COMMUNITY ZONING APPEALS BOARD 10

1. DAGOBERTO CASTRO (12-4-CZ10-1/11-109) **17-54-40**
Area 10/District 10

Miami-Dade County Department of Permitting, Environment and Regulatory Affairs
Staff Report to Community Council No. 10

PH: Z11-109 (12-04-CZ10-1) **April 4, 2012**
Item No. 1

DATE: 3-24-2011
LIC.#AA-C002179
LIC.#FILER: 3144
HAMMOND:#5159
COMM. NO.: 1111
TITLE: SITE PLN
SHEET: A-1

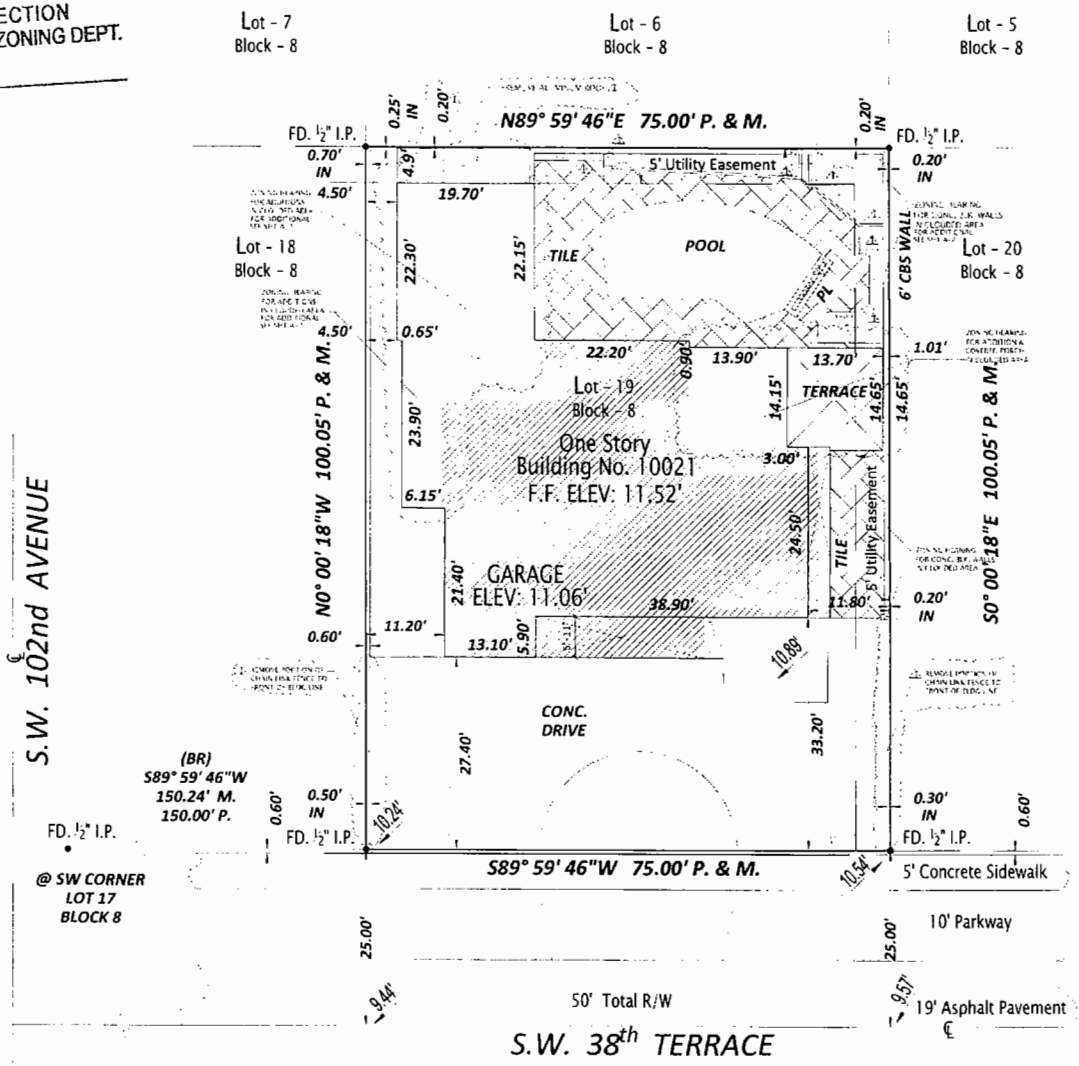
6. That the existing aluminum roof in the rear (north) setback area be removed as shown on the plans.

7. That the applicant maintain the visual buffer along the rear (north) and interior side (west) property lines either in the form of 6' high wood fence or CBS wall.

8. That prior to issuance of a building permit, the applicant submit approvals from the utility companies agreeing to the encroachments into the utility easements as indicated in the plans.

DATE: 3-24-2011
LIC.#AA-C002179
LIC.#FILER: 3144,
HAMMOND:#5159
COMM. NO.: 1111
TITLE: ASBUILT PLN
SHEET: A-2

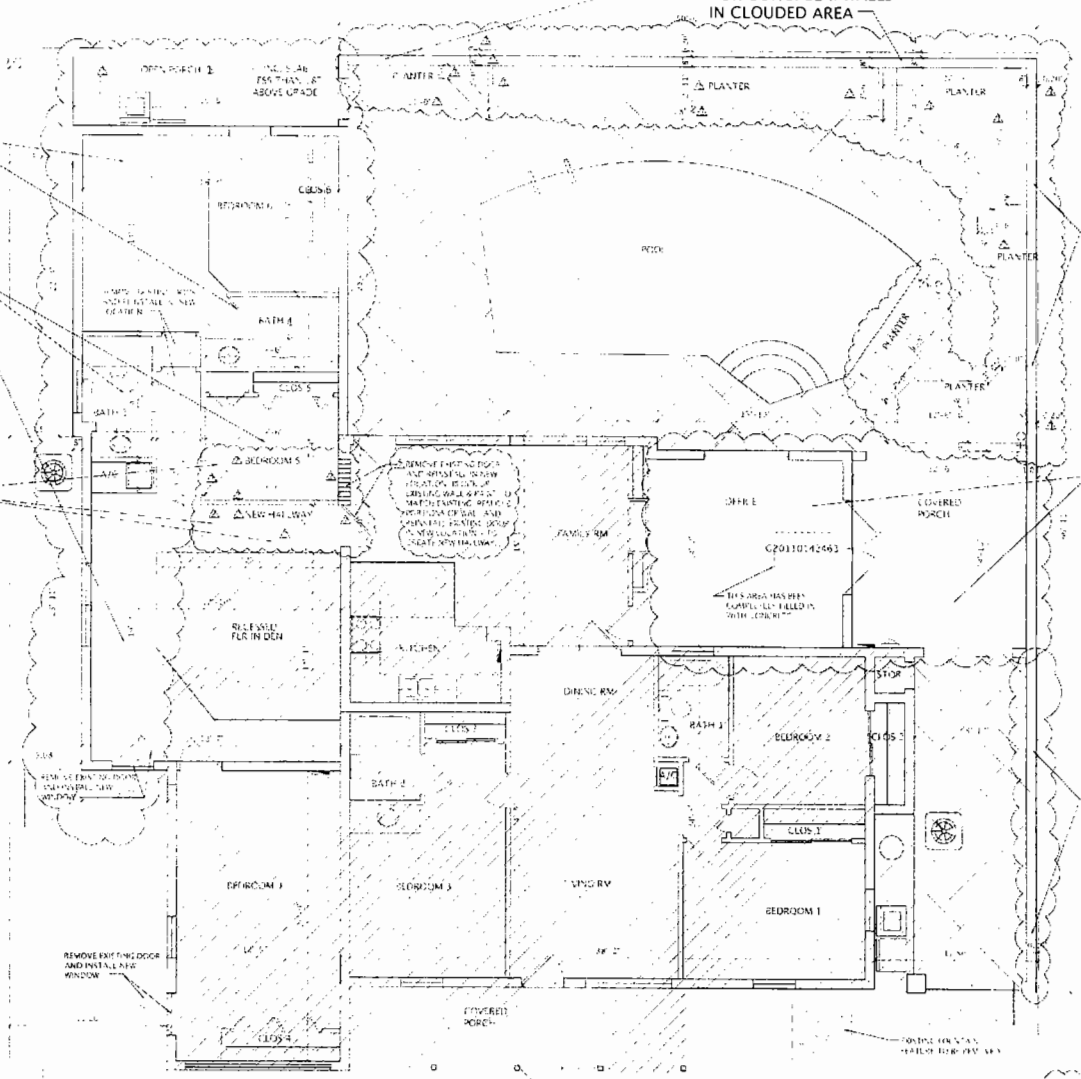
However, when request #2 is similarly analyzed under the Section 33-311(A)(4)(b), Non-Use Variance Standards, staff opines that approval of this request will not maintain the basic intent and purpose of the zoning, subdivision and other land use regulations and would be **incompatible** with the same. In fact, staff's research of other properties in the surrounding area did not indicate any similar approvals of interior side setback encroachments as intensive as what is being requested herein. As such, staff opines that the approval of the applicant's request for the existing covered terrace addition to the single-family residence to encroach 6.49' into the interior side (east) setback area (7.5' required) would be overly intensive and would therefore be out of character and **incompatible** with the surrounding residential developments. **Staff therefore, recommends denial without prejudice of request #2 under the Section 33-311(A)(4)(b), Non-Use Variance standards.**

Furthermore, based on the configuration of the floor plans, staff opines that future owners could easily convert the existing residence to allow a multiple residential use. Therefore, staff recommends as a condition for approval, that the applicant submit a Declaration of Use agreement which restricts the use of the subject property to a single-family use only. Additional conditions for the approval of this application include that the exterior door leading outside from the rear (north) bedroom be replaced with a window and that the existing aluminum roof, located in the rear (north) setback area be removed as shown on the plans. **As such, staff recommends approval with conditions of requests #1 and #3, denial without prejudice of request #2, and modified approval with conditions of request #4 to permit a lot coverage of 40.59%.**

5. That the exterior door leading outside from the rear (north) bedroom be replaced with a window.

DATE: 3-24-2011
LIC.#AA-C002179
LIC.#FILER: 3144,
HAMMOND:#5159
COMM. NO.: 1111
TITLE: LANDSC
SHEET: L-1

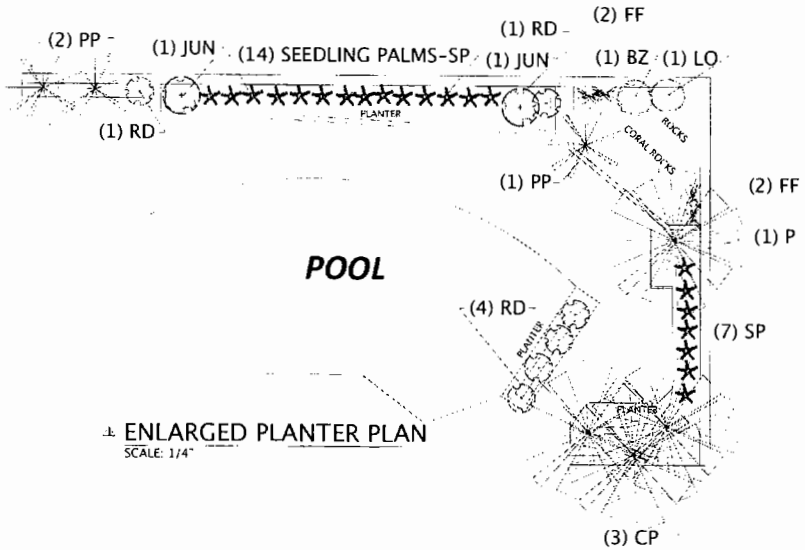
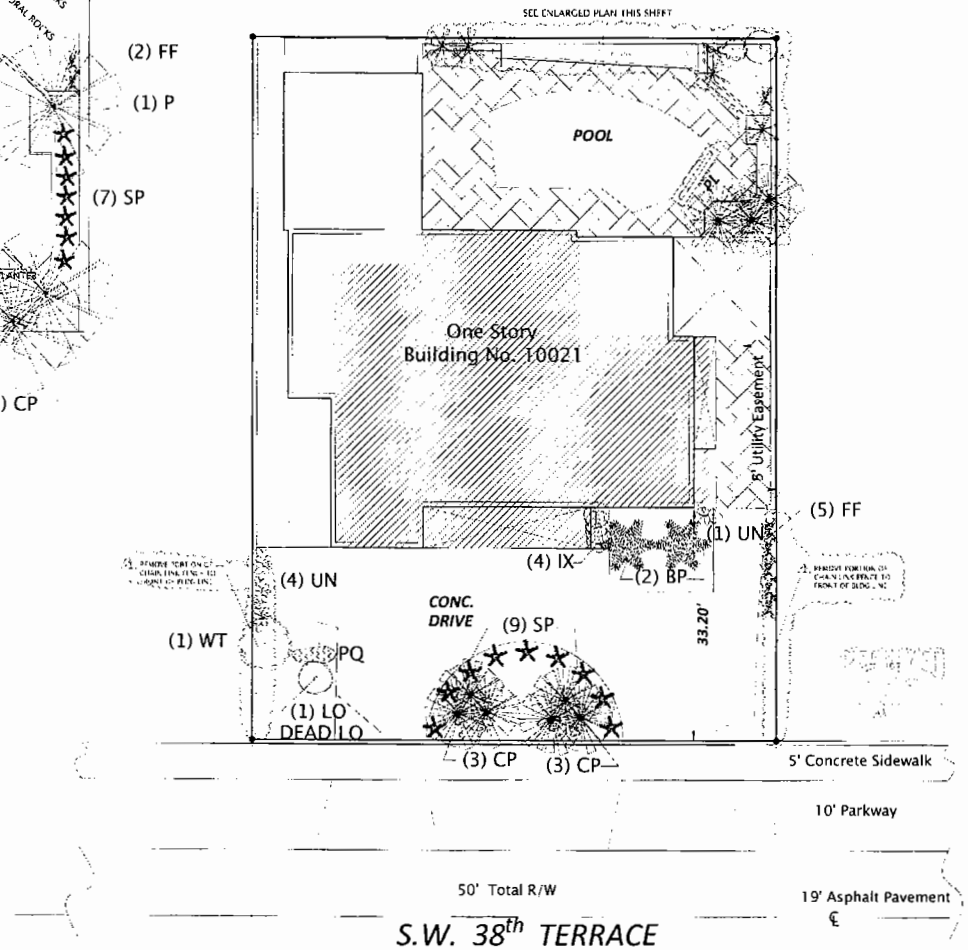
compatible with same. Staff opines that the requested encroachments in requests #1 and #3 are not likely to affect the stability and appearance of the community. Therefore, staff recommends that as a condition for approval of this application, that the applicant maintains the visual buffer along the rear (north) and interior side (west) property lines to mitigate any negative visual impact from the aforementioned encroachments on the abutting properties. **Staff therefore, recommends approval with conditions of requests #1 and #3 under the Section 33-311(A)(4)(b), Non-Use Variance standards.**
